RE: SUBMISSION TO SSD-78156462 FOR RESIDENTIAL FLAT BUILDING WITH INFILL AFFORDABLE HOUSING

Thank you for the opportunity to comment on State Significant Development (SSD) application (SSD-78156462) for demolition of existing structures and construction of a residential flat building including infill affordable housing at No. 12-16 Bent Street, Lindfield.

Ku-ring-gai Council's objection/submission to SSD- 78156462 for residential flat building with infill affordable housing at No. 12-16 Bent Street, Lindfield

Figure 2: Height of building as shown on the sections (AR-DA-D10010 prepared by PTW, dated 3 March 2025)

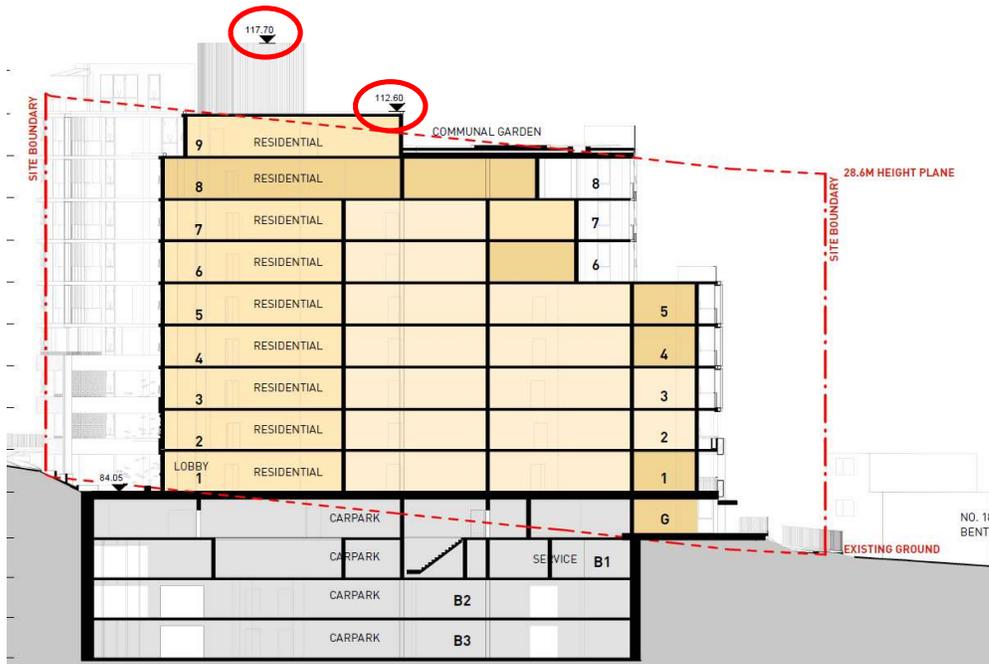
The height of the proposed building is difficult to verify based on the documentation provided. The submitted sections do not show existing ground levels nor does the submitted roof plan. Further, the height of the building appears to be shown inconsistently on the architectural plans with heights of RL112.60 and RL117.70 shown on the sections and elevations (**Figure 2**) and heights of RL112.40 and RL117.50 shown on the roof plan (**Figure 3**).

Clarification should be sought from the applicant regarding these inconsistencies. Additional information including a plan overlaying roof levels with existing ground levels and/or a revised "building height blanket" diagram that includes both reduced level (RLs) and measurements in height (metres) must be provided to enable an accurate assessment.

Figure 4: Building height blanket as shown within the Clause 4.6 variation request (prepared by Willowtree Planning, dated 4 April 2025)

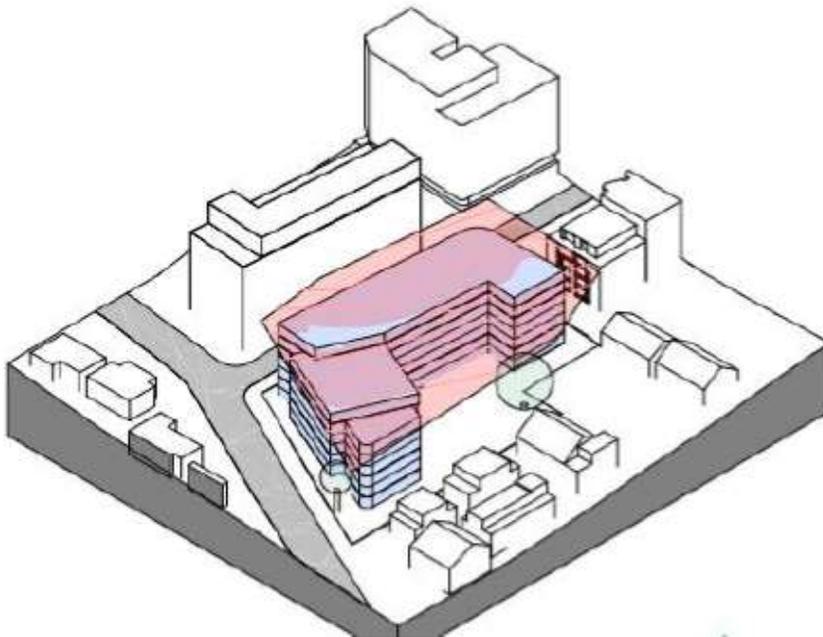
The Clause 4.6 variation request is not considered to be well founded as it does not accurately articulate where the breach of the development standard occurs. Further, the information within the Clause 4.6 variation request regarding the height breach is inconsistent with the architectural plans. The Clause 4.6 variation request indicates that the breach occurs for a small extent of the building only (the blue area shown in **Figure 4**).

However, this is inconsistent with the building height blanket provided within the architectural plans which shows a larger building envelope and a greater extent of height breach (the white area shown in **Figure 5**). The height breach indicated on the architectural plans is significant and amounts to the majority of the top floor and part of the roof below. For the Clause 4.6 variation request to be well founded, the variation from the development standard must be clearly articulated and justified.

Figure 6: Excerpt from Part 14E.13 of Ku-ring-gai DCP

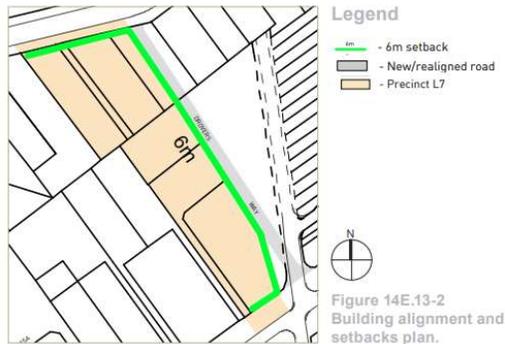
The proposed setback of 3m to future Drovers Way will not create a cohesive streetscape along Drovers Way and is strongly objected to by Council. Compliance with the 6m setback control within the KDCP must be enforced.

A preliminary review of the recently lodged DA at Nos. 3 and 3A Beaconsfield Parade (the site immediately to the south) indicates a proposed 6m setback to the future Drovers Way. Therefore, a 6m setback to Drovers Way must be provided for the subject site to create a cohesive streetscape and enable the planting of tall trees within both setbacks to maintain the landscape character.

Figure 9: Cross ventilation diagram for level 5 (AR-DA-Q4-0010, prepared by PTW dated 3 March 2025)

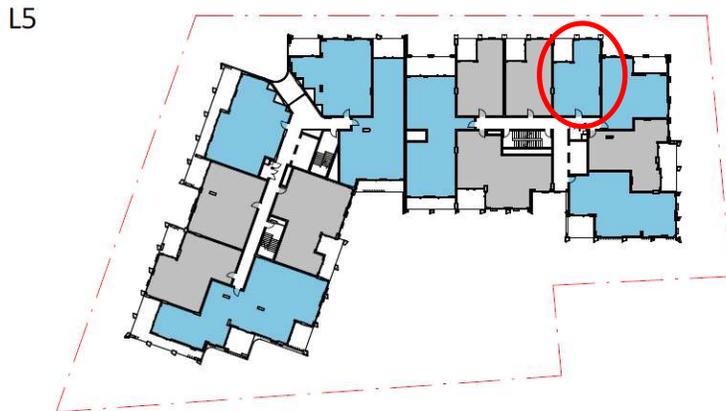
Cross ventilation diagrams have been provided but should be checked by the consent authority. It appears that some of the units marked as being cross ventilated provide limited cross ventilation through one room only e.g. Units 312, 412 and 512 (see **Figures 9 and 10**). If these units are found to be inadequately ventilated, compliance with Objective 4B-3 of the ADG will not be achieved.

Figure 1 – Extract from Council's contour and drainage maps

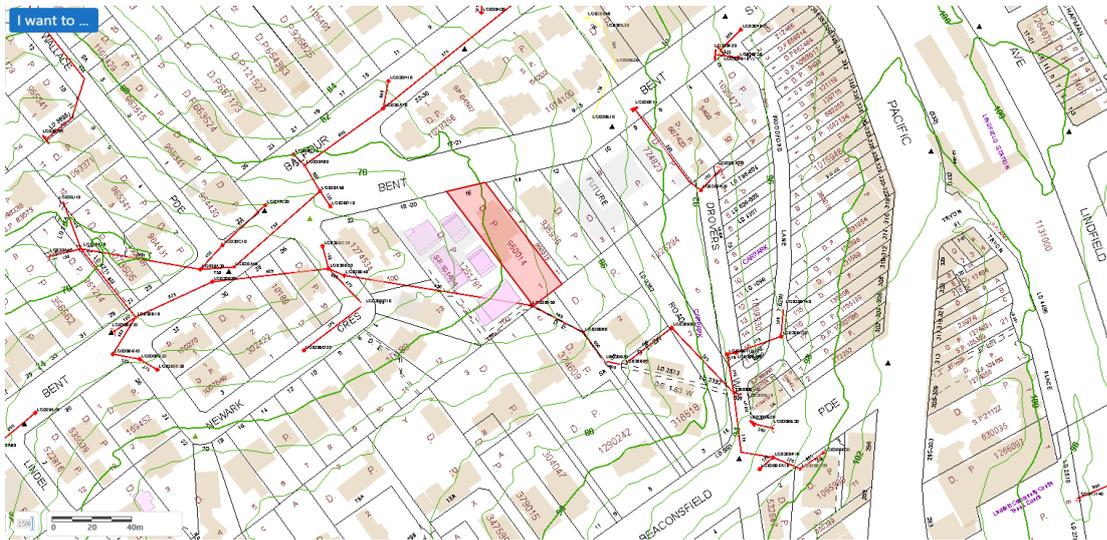
The subject site has a crossfall of approximately 8m allowing stormwater runoff to be directed to the street drainage in Bent Street. Alternatively, it may be directed to Council's trunk drainage system located within 18-20 Bent Street which would be subject to obtaining an inter-allotment drainage easement from the downstream property prior to direct connection.

- The condition of the existing pipe along the easement route is to be inspected by a licenced plumber to verify that the existing pipe is in good working condition. The findings of the plumber's report are to be submitted with the application. A CCTV video and report of the existing pipe within the easement shall form part of this required certification.

- If connection to this easement is proposed, then supporting hydraulic calculations must be submitted to verify that the pipe within the existing drainage easement has sufficient capacity to handle the post development flows as well as including provisions for overland flow as per Control 30 of Part 24R.6 of the Ku-ring-gai DCP.
